Addendum No. 2

Subject: John M. Patterson Elementary School
2022 Classroom Modernization
SDP Contract Nos. 2022-010-G, 2022-010-P, 2022-010-E

Location: John M. Patterson Elementary School
7001 Buist Avenue
Philadelphia PA 19142

This Addendum No. 2, dated FEBRUARY 18, 2022, shall modify and become part of the proposed Contract Documents of the work of this project. Any items not mentioned herein, or affected by, shall be performed strictly in accordance with the original Contract Documents, unless modified by prior addenda.

2 ELECTRICAL ANNEX LIGHTING NEW WORK PLAN SCALE: 1/8" = 1'-0"

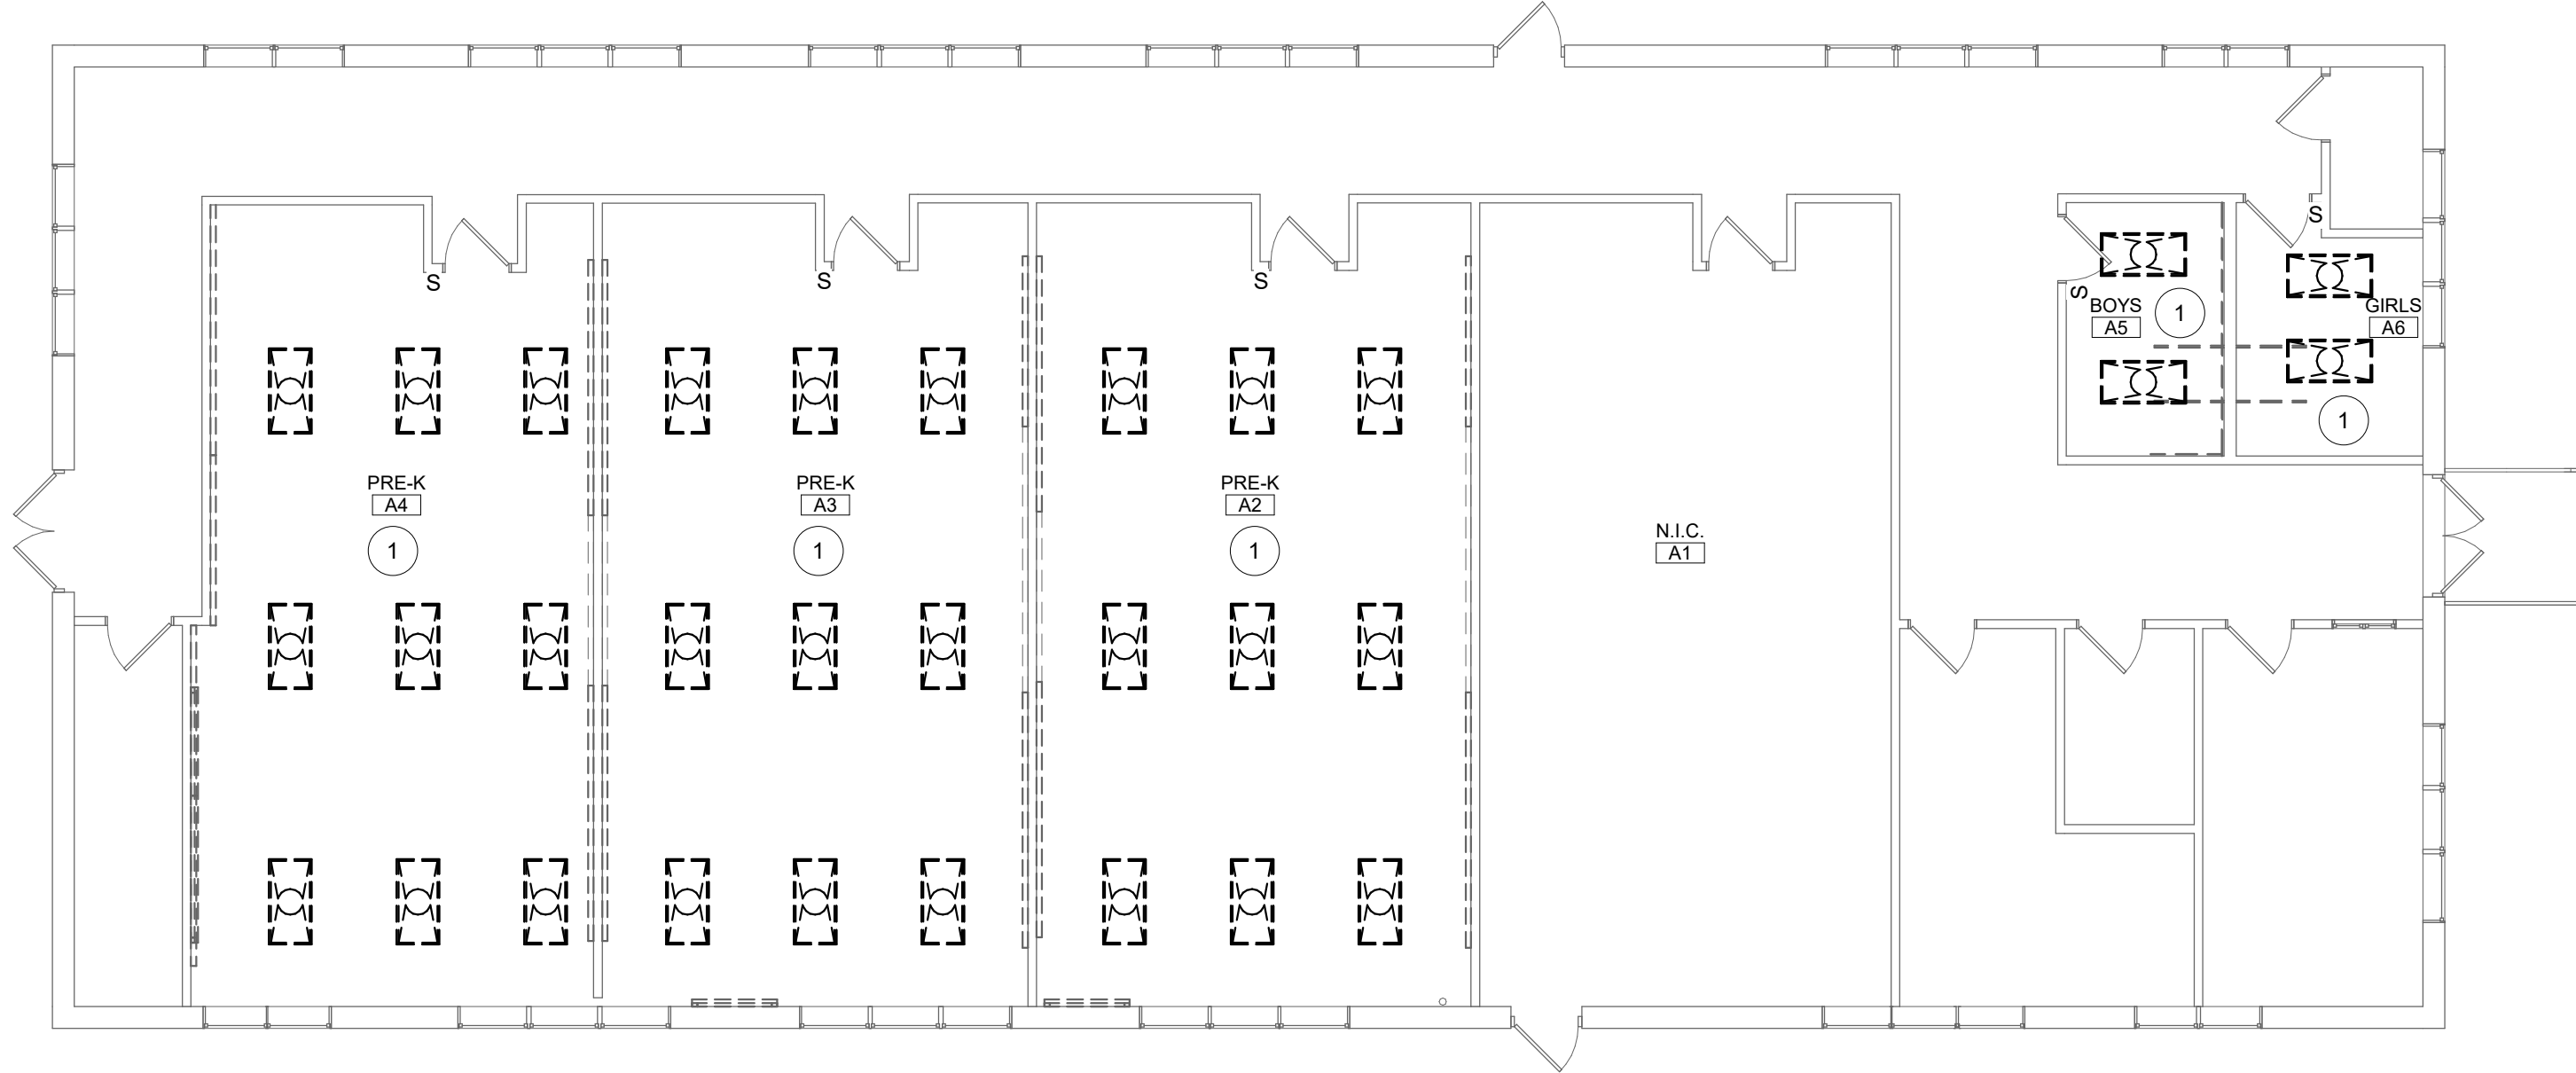
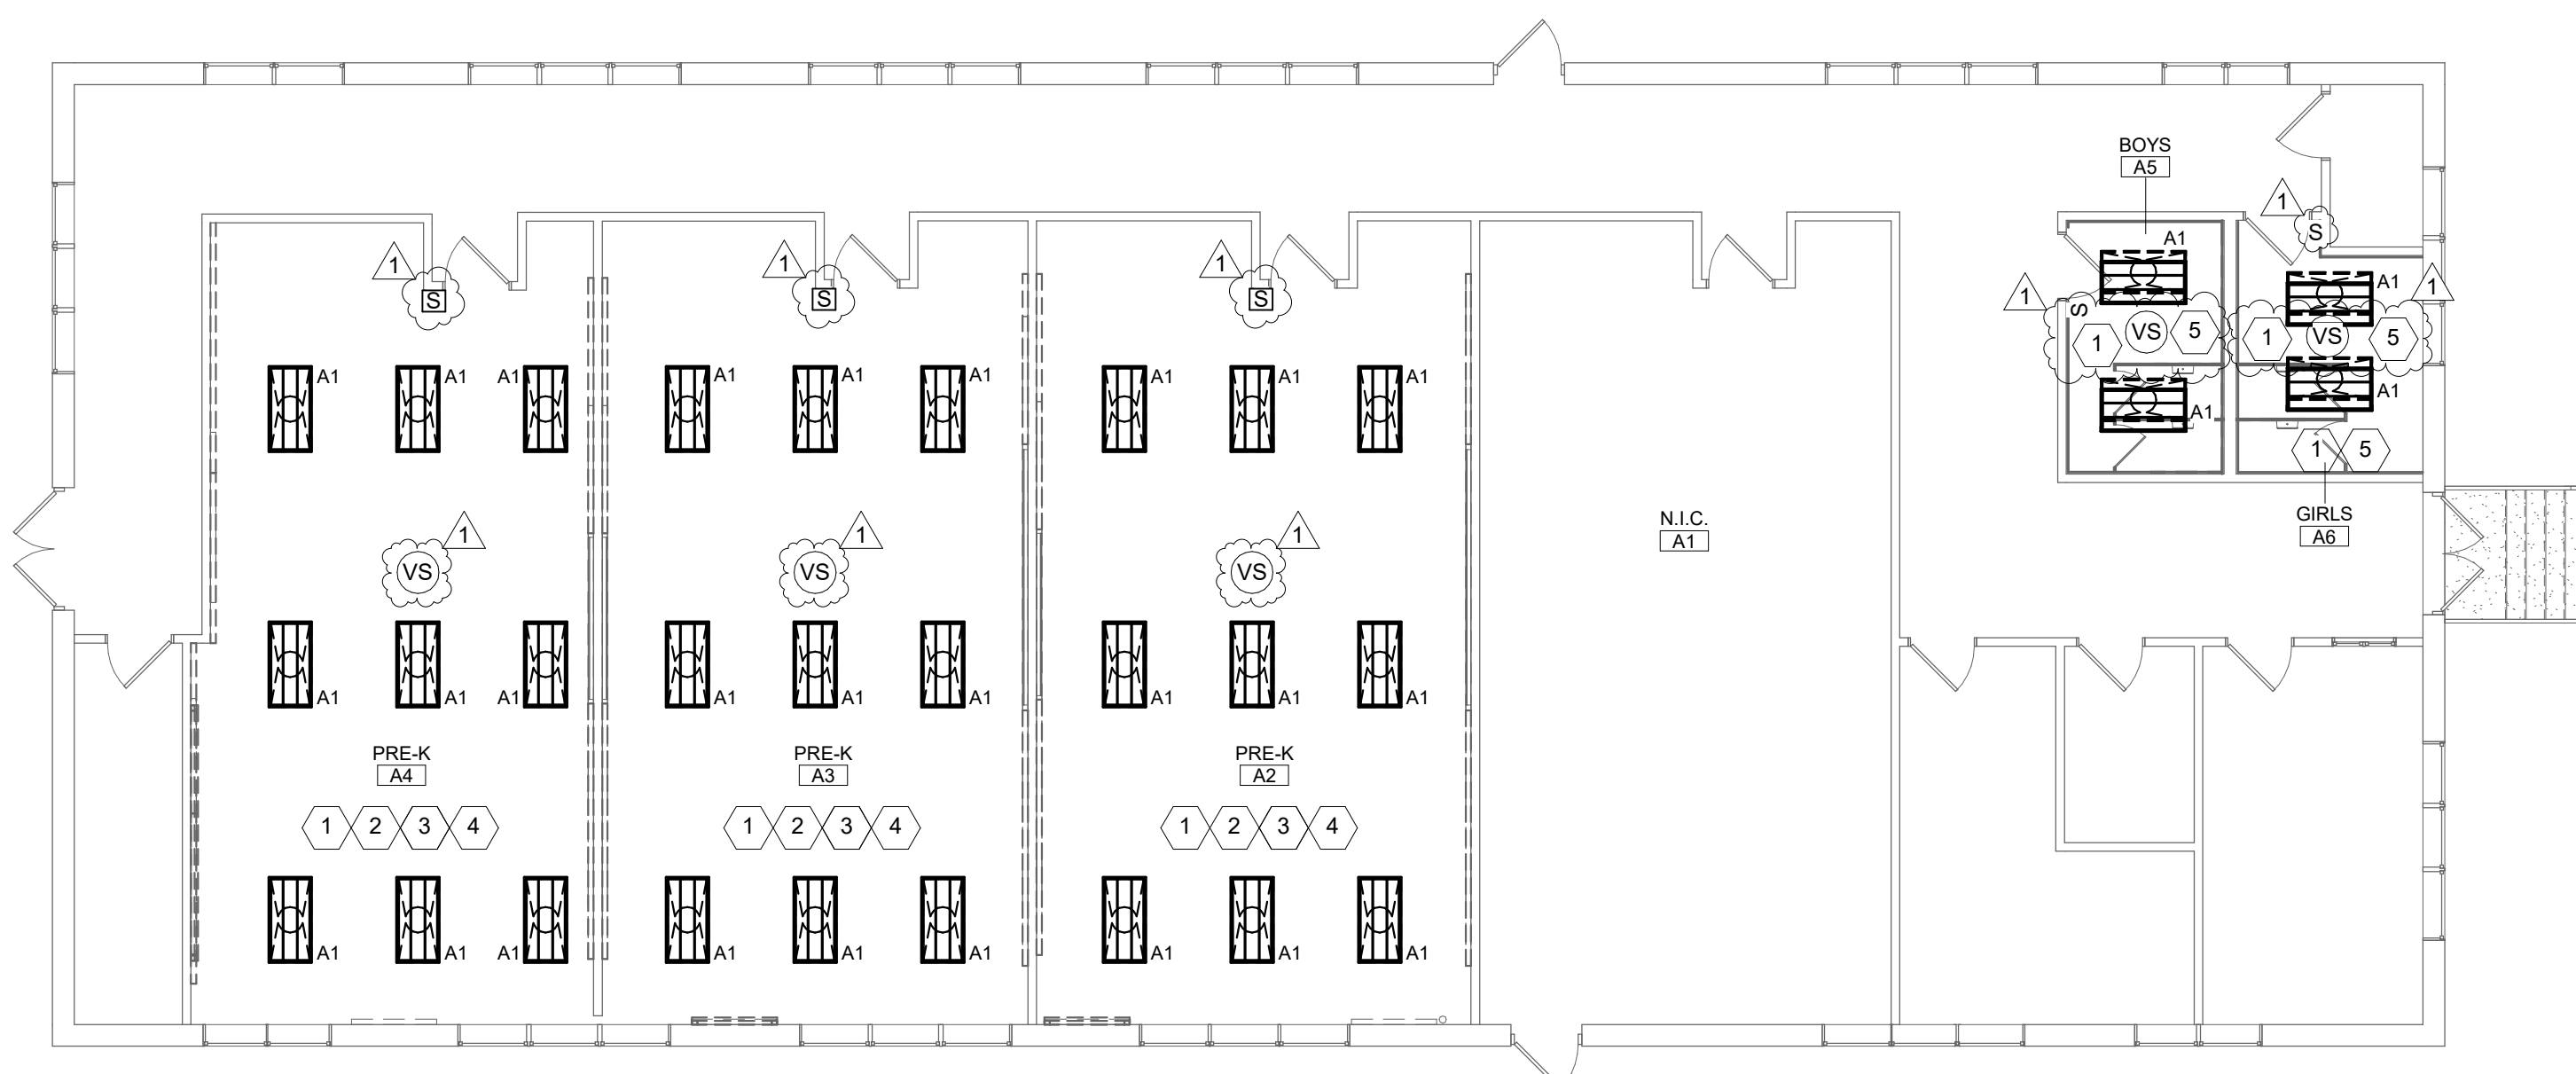
17. **Question:** Drawing E200 specifies type A1 fixture on the fixture schedule. The lumen selection per the fixture schedule catalog number is “384L” which is not possible per the cut sheet and appears to be a typo. Please clarify lumen section.

Response: Refer to lighting fixture schedules on revised E200 series drawings attached.

1 ELECTRICAL FIRST FLOOR LIGHTING NEW WORK PLAN
SCALE: 1/8" = 1'-0"

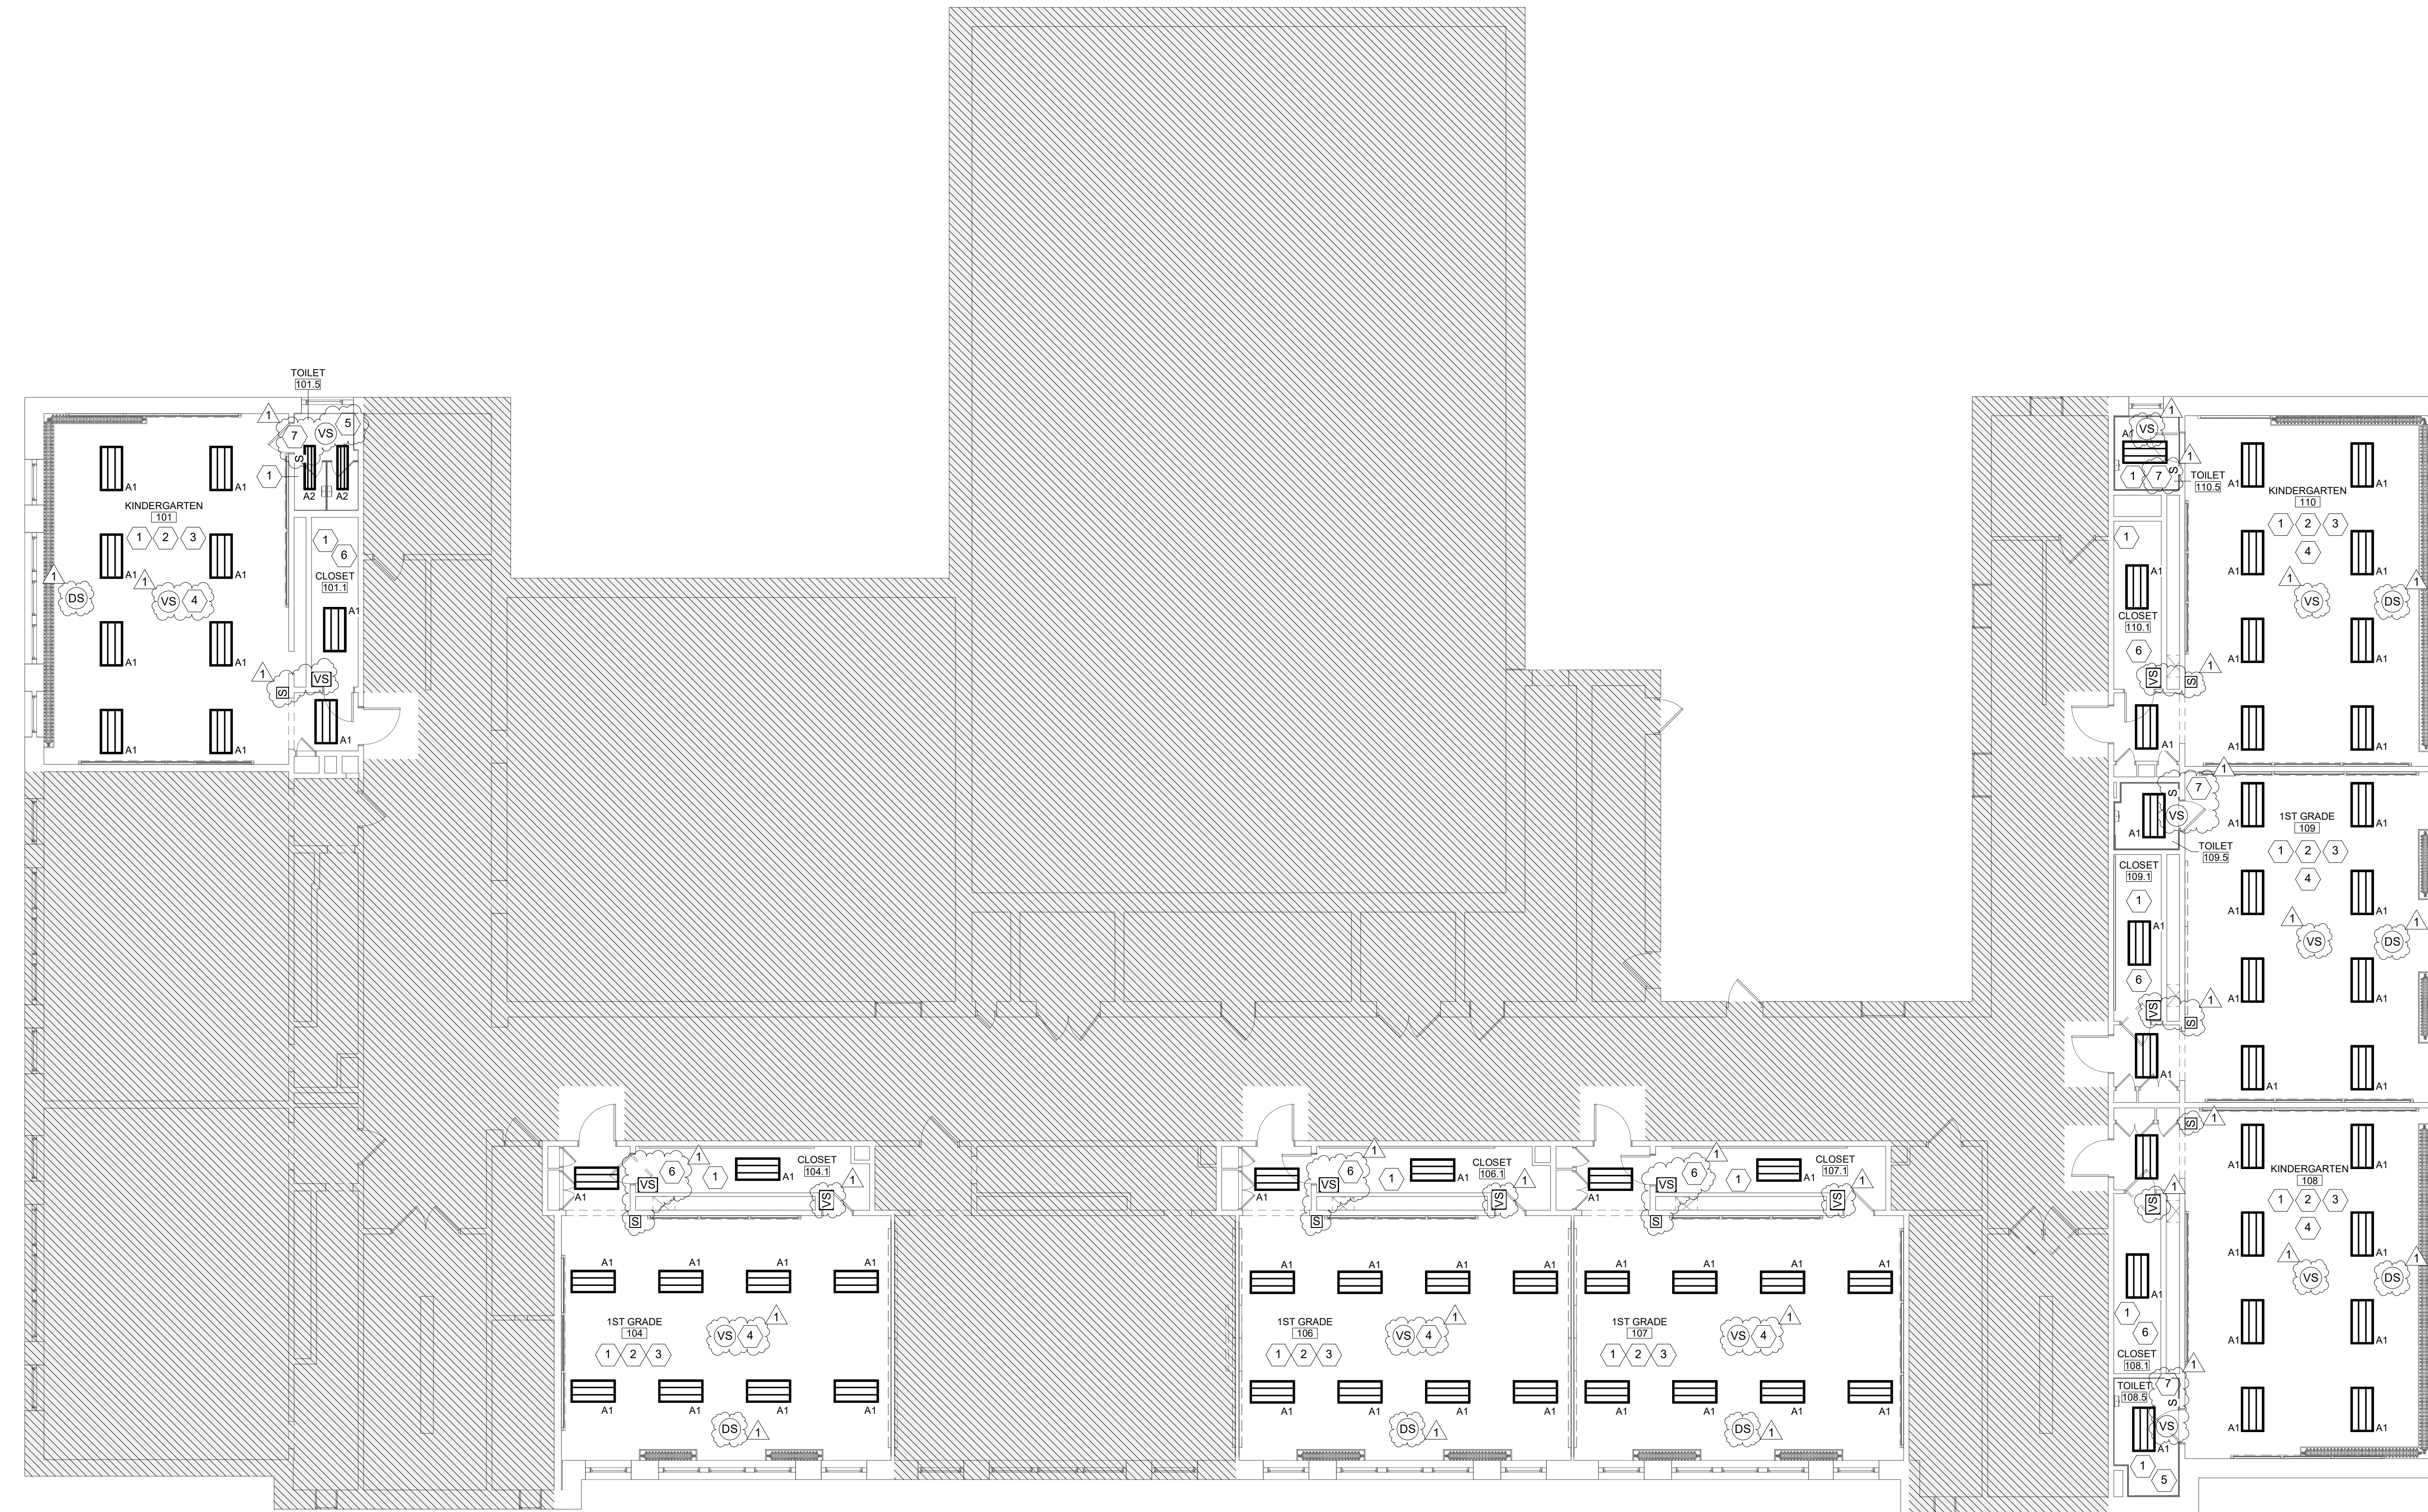
15. **Question:** Drawings E200, E201, E202, E203 sheet new work keynote #1 calls for dimming lighting controls in the classrooms but the note has very little detail on design requirements. The floor plans show nothing in terms of design for the lighting controls (control layout, zoning, basis of design part numbers etc.). The floor plans conflict with keynote #1 and show single pole switches which do not dim. Why was a design not provided with basis of design control part numbers like all other typical SDP projects? If no design will be provided, please answer questions below.

Response: Refer to revised E200 series drawings attached.
